SUBJECT: Forwards response to 860708 request for addl info re emergency diesel generator load evaluation.

L-86-295

Re: Turkey Point Units 3 and 4
Docket Nos. 50-250 and 50-251
Request for Additional Information
Emergency Diesel Generator Load Evaluation
NRC TAC Nos. 61211 and 61212

FIGURE RAI-2

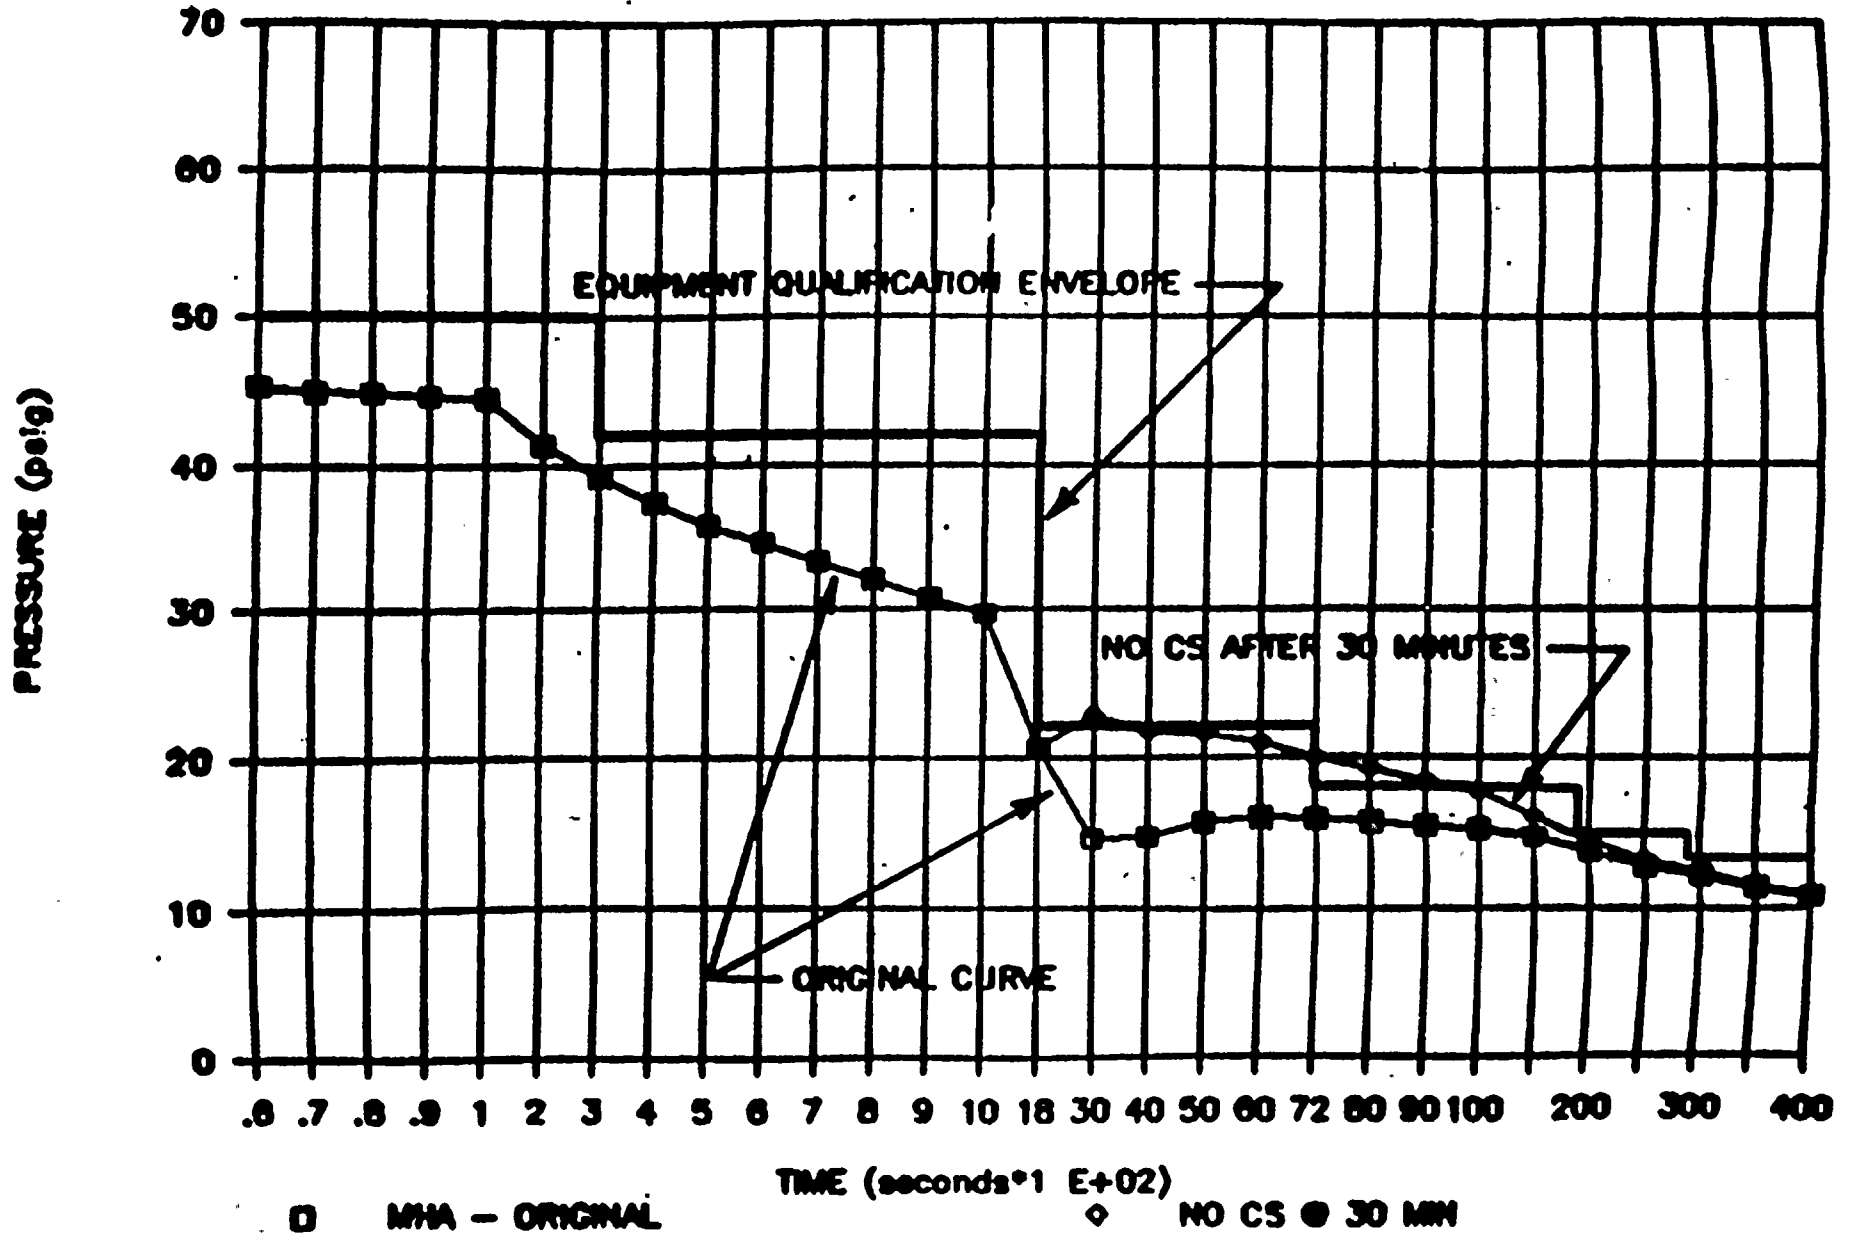
Provide the plot of containment atmosphere pressure that corresponds with the plot of containment atmosphere temperature provided as Figure 3 in the June 12, 1986, submittal.

The requested pressure versus time curve is attached as Figure RAI-2.

Containment pressure in psig, as shown on Figure RAI-2, represents the total of the air and steam partial pressures in the steam/air mixture. Temperature of the mixture is the saturation temperature at the steam partial pressure and is provided as Figure 3 of the EDG Load Evaluation.
